Title: **Addendum Section 42A Officer's Report**

Applicant:	Simon Cave
Location:	4,6 and 8 Tuahine Crescent, Wainui Beach
Legal Description:	Lots 5, 6, and 7 DP 3216
District and Regional Plans:	Te Papa Tipu Taunaki o Te Tairāwhiti – Tairāwhiti Resource Management Plan (Tairāwhiti Plan)
Proposal:	To construct a revetment wall at the toe of the dune below 4, 6 and 8 Tuahine Crescent

Addendum Report to Commissioner for decision

Review of coastal process impacts of proposed Tuahine Crescent Seawall

Figure 1: Detail of revetment wall design from original resource consent application.

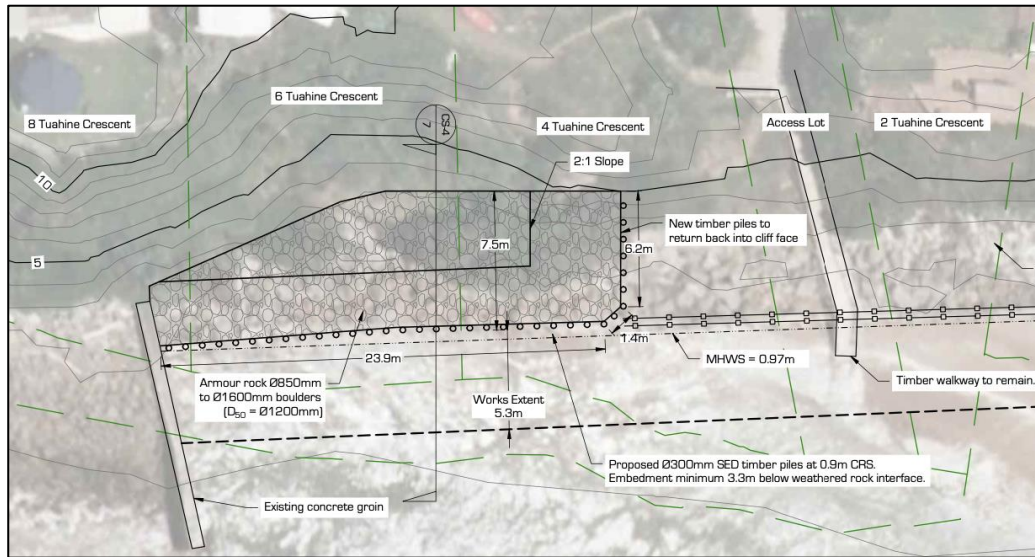
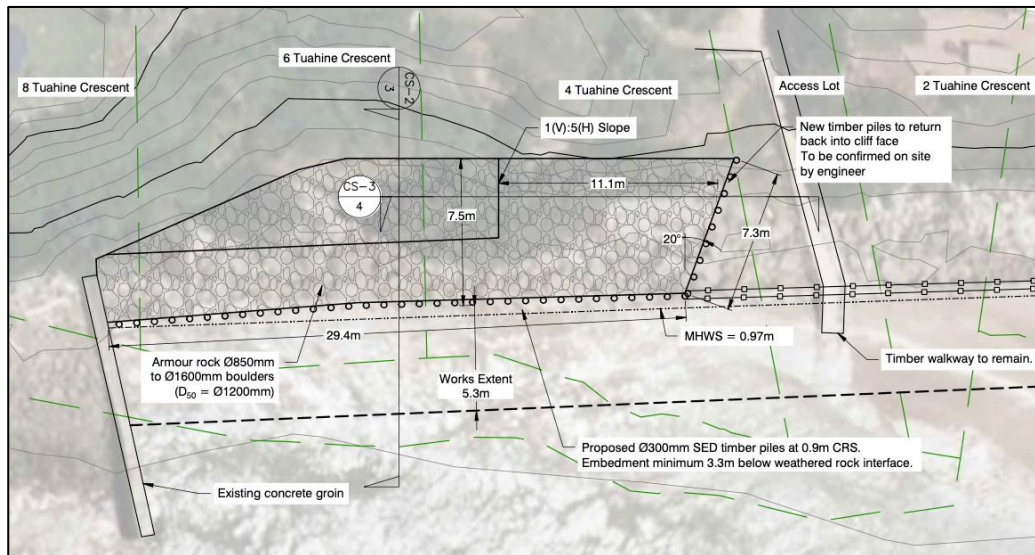
In discussing the conditions with the Applicant, a request has been made to amend the plan references for the wall design from those submitted with the original resource consent application with those submitted with the EUC application.

I understand that the design change has been made to better address potential wall end effects with the length of the front face of the wall increasing from 23.9m to 29.4m and a 20 degree taper on the wall return as shown in **Figure 1** and **Figure 2**.

The increase in the length of wall is not large physically, however it does represent a reasonably large proportionate increase of approximately 23%. As such, it is my opinion that the Applicant will need to provide planning and legal submission to enable a proper evaluation of whether it is appropriate to accept the amended design plans should the Commissioner be mindful to grant consent.
